**CALIFORNIA COASTAL COMMISSION**

**RECORD PACKET COPY****STAFF REPORT: APPEAL**  
**SUBSTANTIAL ISSUE**

**APPEAL NUMBER:** A-5-RPV-00-296

**PROJECT LOCATION:** Abalone Cove Park, Palos Verdes Drive, Rancho Palos Verdes, CA

INCLINE  
FROM UPPER  
PROPOSED  
LOT TO LOWER

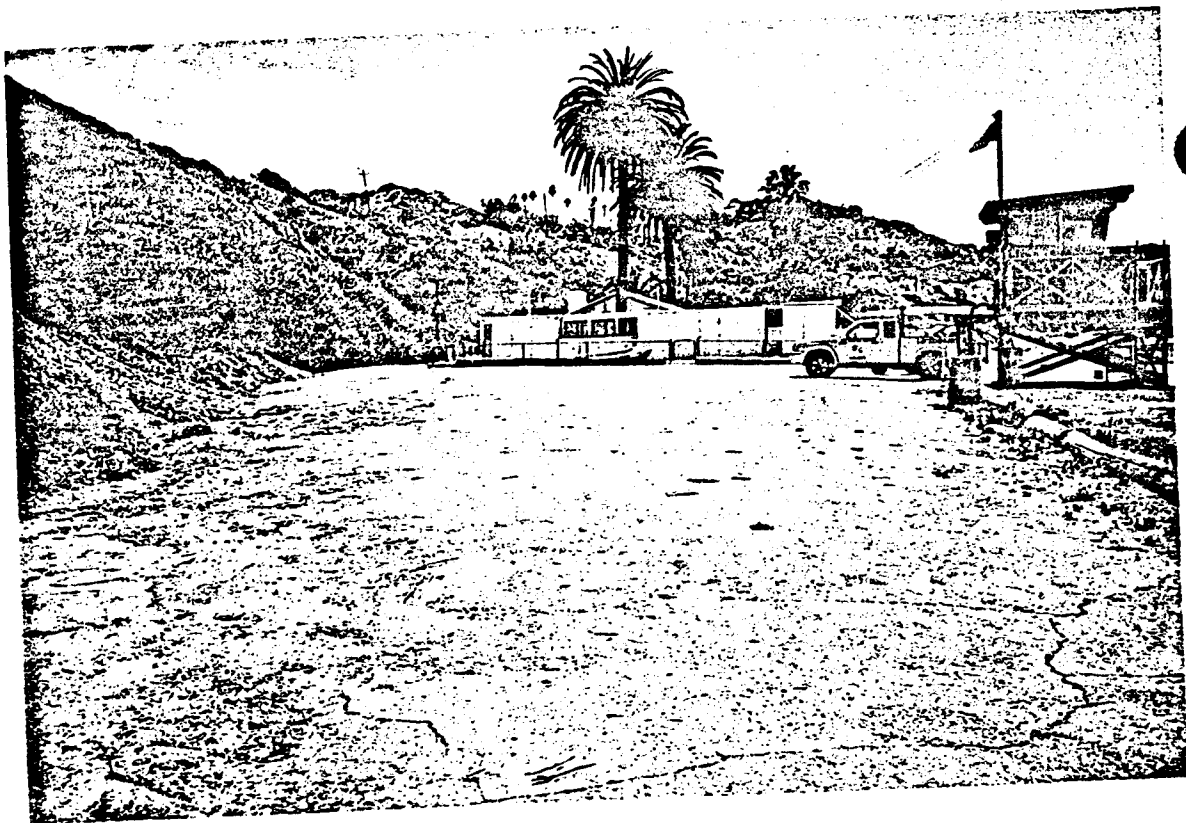
The 15 space proposed parking lot above cannot provide handicapped access to the beach edge as the slope leading to the beach from this proposed lot is too steep. If you will notice the topographical lines in the drawing indicate a very steep incline between the proposed parking lot and the existing lower lot.

CURRENT  
BEACH  
SCHOOL

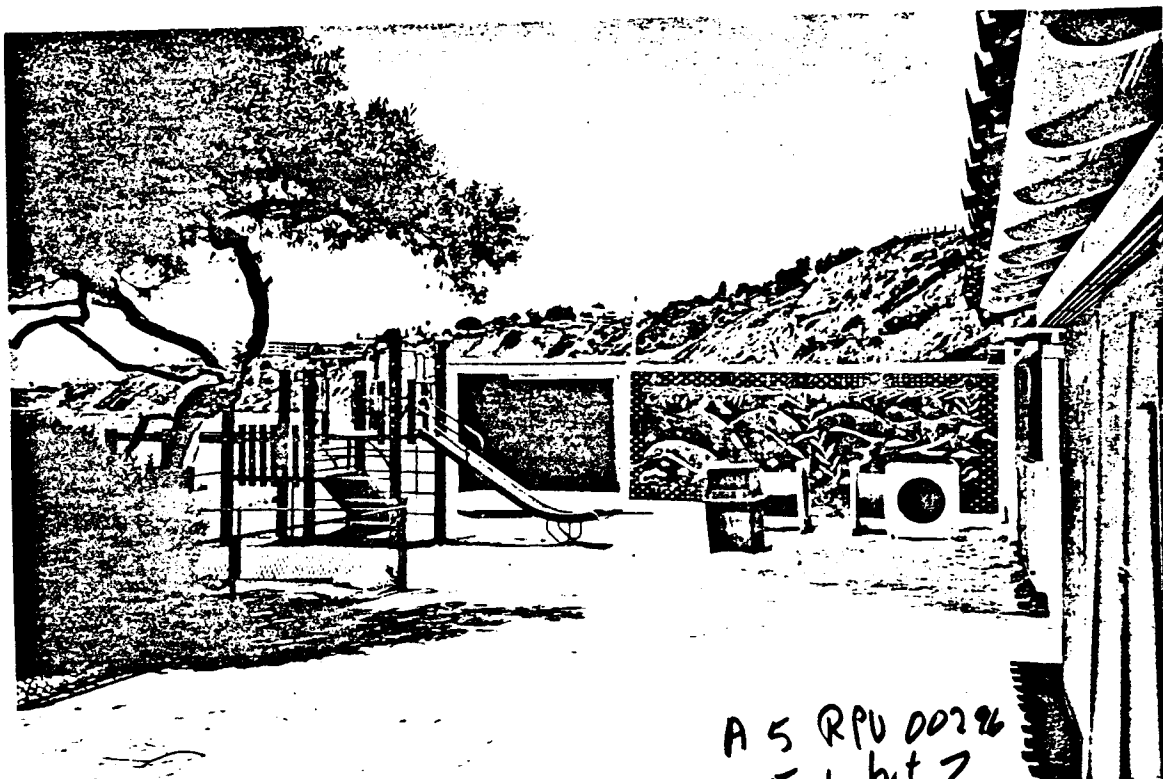
As you can see in exhibit H, the existing nursery school looks fine. As a matter of fact, all of the parents of the children who attend this nursery school volunteer to keep up the structures. I know because I am one of those parents. The beautiful mural of dolphins you see was painted, free, by one of the parents. The city plans to tear it down to build their new structures.

"L"  
OPEN 1/2  
CULVERT

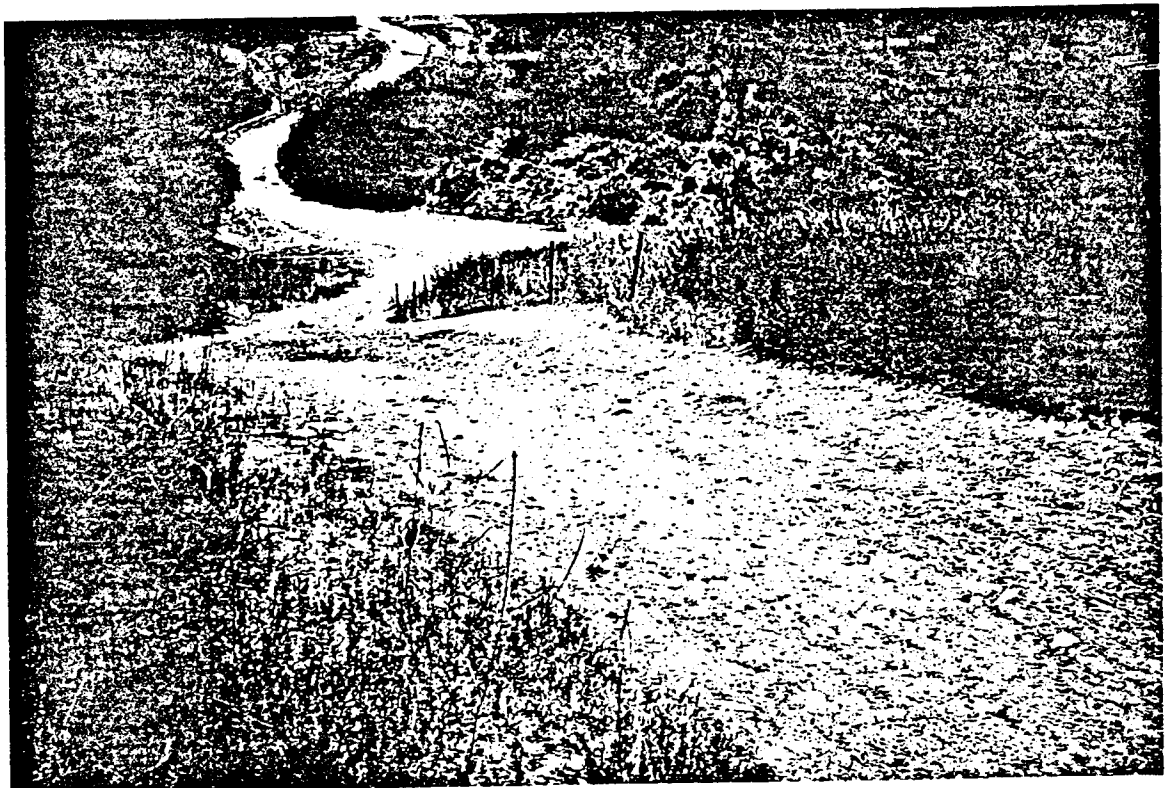
Currently there is a half culvert that channels water out of a dewatering well down to the shoreline. The project plan calls to replace this with a covered pipe. Yet the MND has not studied whether or not the insects, birds of other animals, including endangered species, utilize this open channel for a water source. It is currently a year-round source of water so it would seem reasonable that it could be an important negative environmental impact to cover this source of water. SEE EXHIBIT L
